BEACON PLANNING BOARD
Via Video-Conference
BEACON, NEW YORK 12508
Phone (845) 838-5002 Fax (845) 838-5026

Conklin Street - Beacon Views

Continue public hearing for SEQRA environmental review on applications for Subdivision and Site Plan Approval, "Beacon Views Townhouses" 39 units, Conklin Street, submitted by Beacon Views, LLC

RE: Beacon Views Site Plan and Conservation Subdivision
Conklin Street
Beacon, New York
Tax Parcel ID: 6055-03-331123

DATE 8-27-19 DRAWN BY J.F.R. SP-1 3

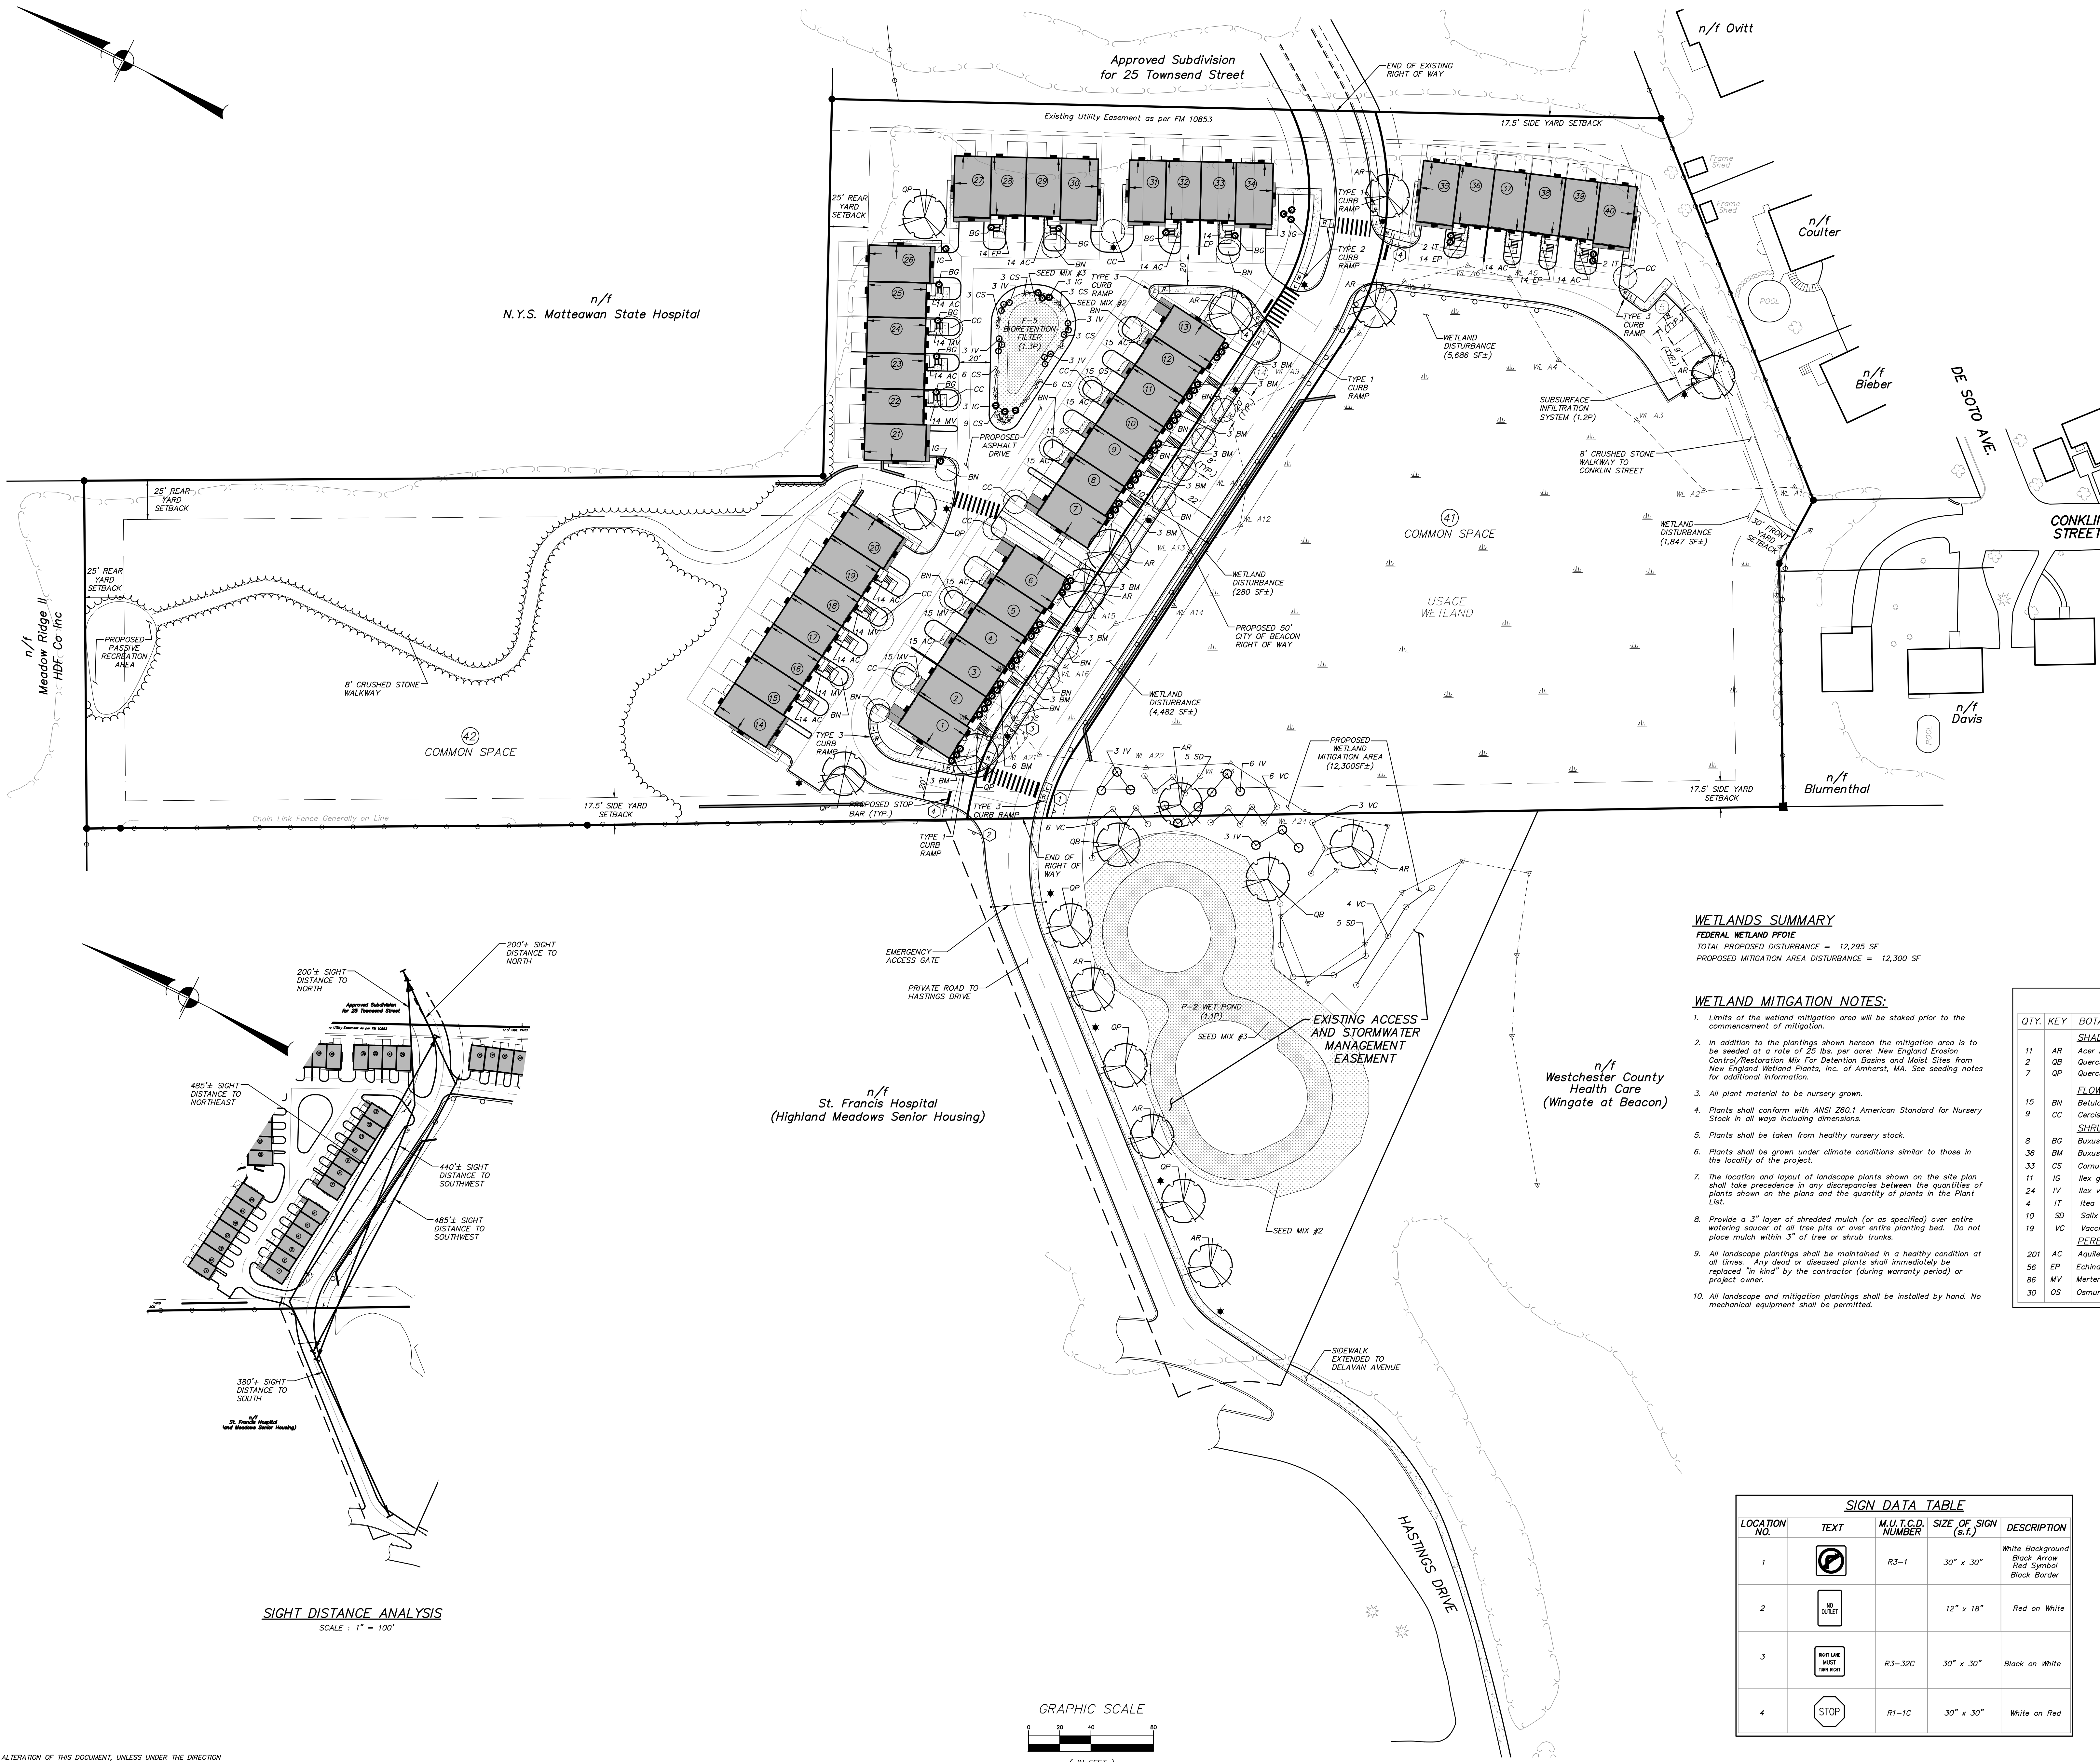
1. Sight distances have been revised to show their full extents.
2. Proposed plantings have been labeled and the schedule has been revised.
3. A Stop Sign has been added to the Sign Table and Stop Signs have been added to both driveways, and the spur road toward Conklin.
4. The signs are labelled in the plan with the corresponding number in the table.
5. As suggested, easements have been created in the rear of lots 1 through 13, and where the lots extend into the commonly used private road. Written descriptions will be provided with a future submission.

1. For the Sheet SP-1 Layout and Landscape Plan, the sidewalk extending to the 25 Townsend subdivision should be separated from the curb line by a 5-foot landscape strip, wherever possible.

DRAWING NO. SP-2.1

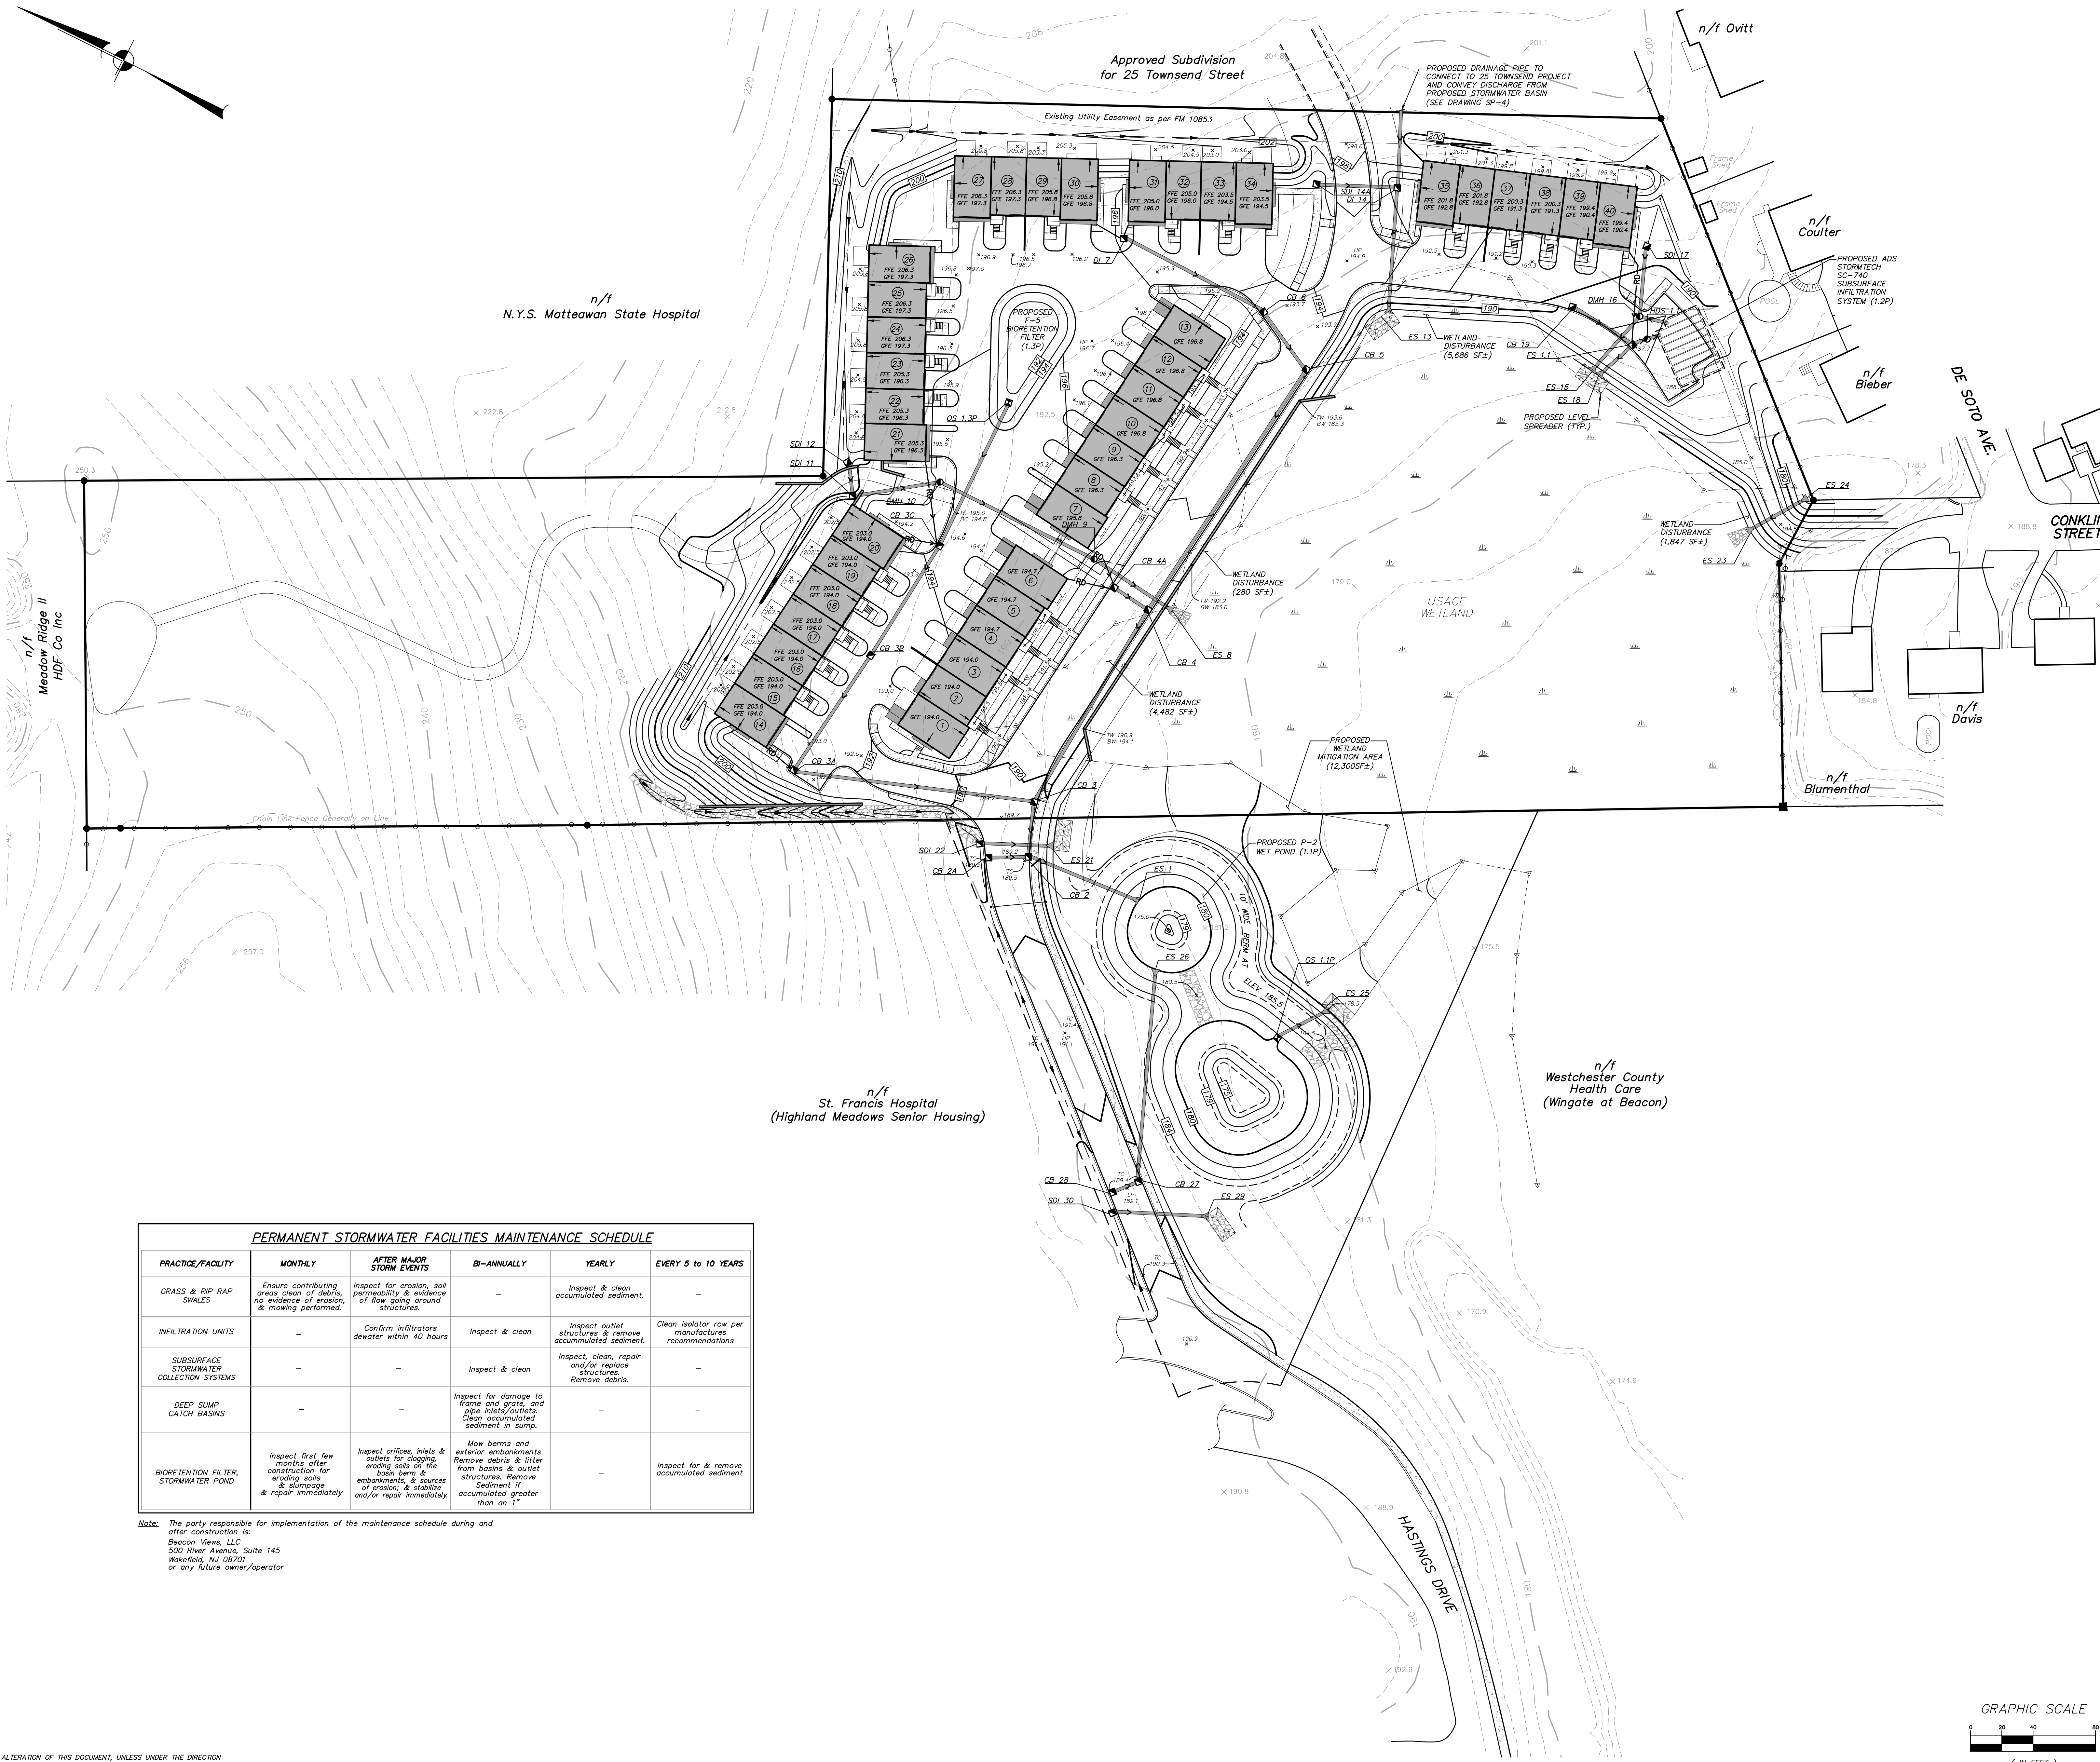
1. See comments No. 1 and 2 above for Sheet 3 of 15.
2. The drainage line running between CB-3 and Cb-5, along the main road, is located within 2 to 5 feet of the proposed retaining wall along the edge of the wetlands. As this wall ranges in height from 6 to 8 feet and is proposed as a modular block wall, this type of wall will require geogrid installed at various layers along the height of the wall to provide wall stability. The geogrid required behind the wall will be in conflict with the proposed drainage line, and will create future problems in maintaining/replacing the drainage line, if necessary, as the grid would have to be removed in turn possibly rendering the retaining wall unstable.
